MIAMI BEACH

PLANNING DEPARTMENT
Staff Report & Recommendation

Design Review Board

SUBJECT: DRB21-0739
291 Palm Avenue

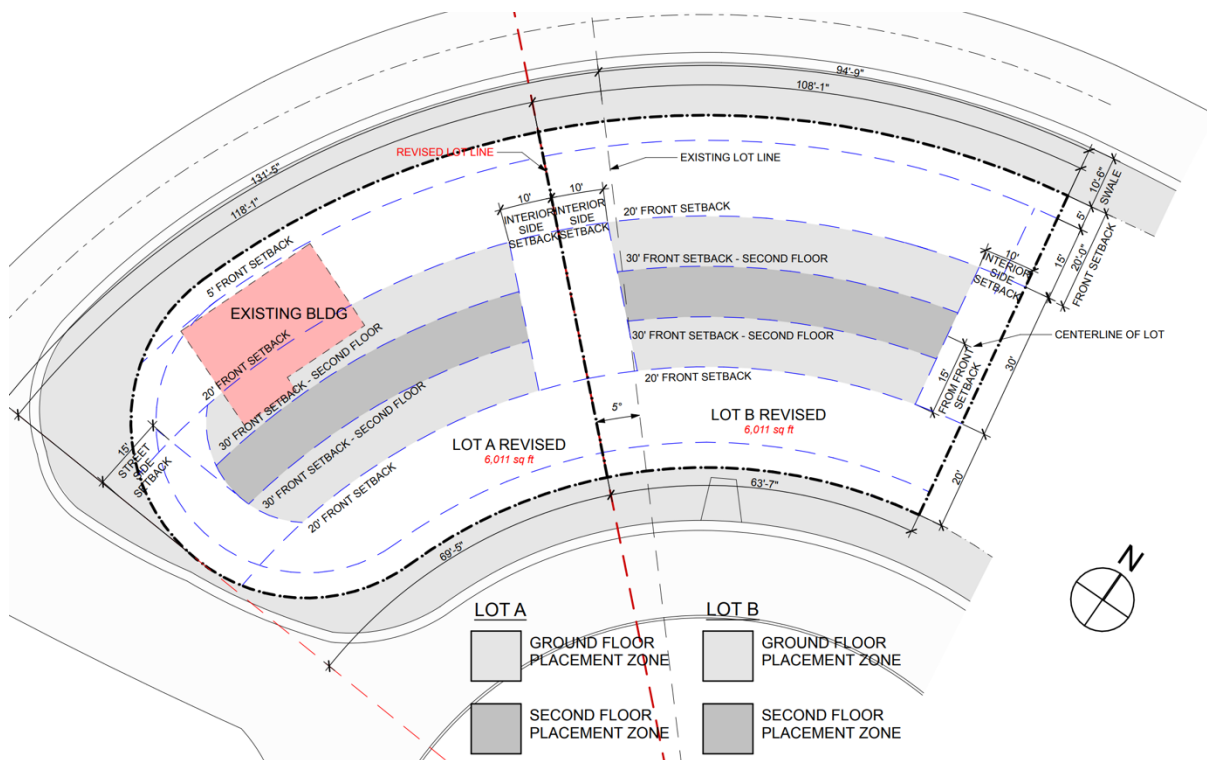
As indicated previously, this lot is rather unique in that it has a curved trapezoidal shape, with two street fronts and is also very shallow, with a lot depth of only 70 feet. Most single family lots on Miami Beach have a lot depth of at least 100 feet. The diagram below shows that absent any relief from the City code, with the current required setbacks, the maximum width of a single-story home is 30 feet, and the maximum width for a 2-story home is only 10 feet. This shallow lot depth, as well as the unique bean shape of the lot, does present a hardship for the construction of any home on the subject site.

With the reduction in unit size, from the previous request of 50% down to 45% - **Variance #2)** and the reduction in lot coverage from the previous request of 31.2% down to 30% - **Variance #1)**, staff is now supportive of these variances, which are now consistent with our prior recommendation.

The subject property is located on the eastern half of an approved lot split application by the Planning Board. Since the newly created lots do not follow the lines of the original platted lots, AND because the prior pre-1942 home will be demolished, the Code limits the maximum lot coverage for a new two-story home to no more than 25% of the lot area, and the maximum unit size shall not exceed 40% of the lot area, or such lesser number, as determined by the planning board. These reduced allowances are intended to mitigate adverse impacts of what could otherwise be a large home on the current site with a unit size up to 50% and footprint of 30%.

Staff would note that the existing homes average unit size (for the study area, included in the Planning Board report) is much larger than the average for most of the City's single family neighborhoods, which is typically around 31%. As such, staff is supportive of the updated variance requests for lot coverage and unit size.
